# SERVICE BULLETIN

Classification: BT99-055	Reference: NTB00-050	Date: June 8, 2000
-----------------------------	-------------------------	-----------------------

## 2000 FRONTIER CREW CAB DRONE NOISE AT 1,000 ENGINE RPM

**APPLIED VEHICLE:** 2000 Frontier (D22) Crew Cab - 2WD A/T ONLY

Figure 1

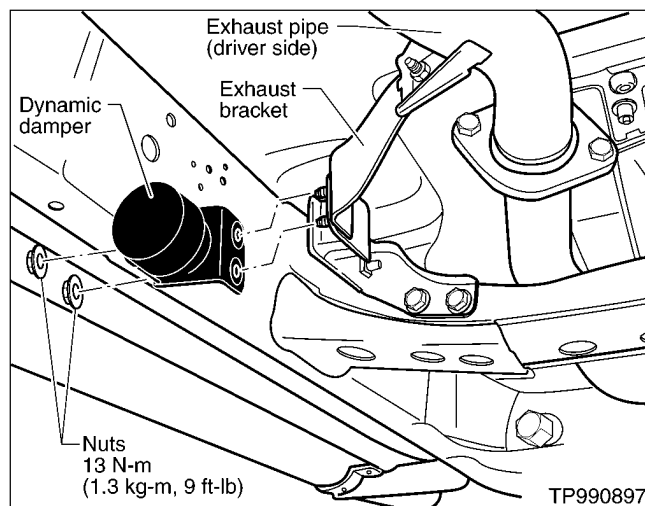
If a 2000 Frontier Crew Cab exhibits a drone noise inside the vehicle during warm-up as the engine speed slowly drops down through 1,000 RPM, use the service procedure listed below to resolve the incident.

Install the dynamic damper on the exhaust bracket and tighten the damper mounting nuts to 13 N-m (1.3 kg-m, 9 ft-lb). Refer to Figure 1 below.

**NOTE:** The nuts for mounting the damper are already on the vehicle (i.e., on the exhaust bracket).
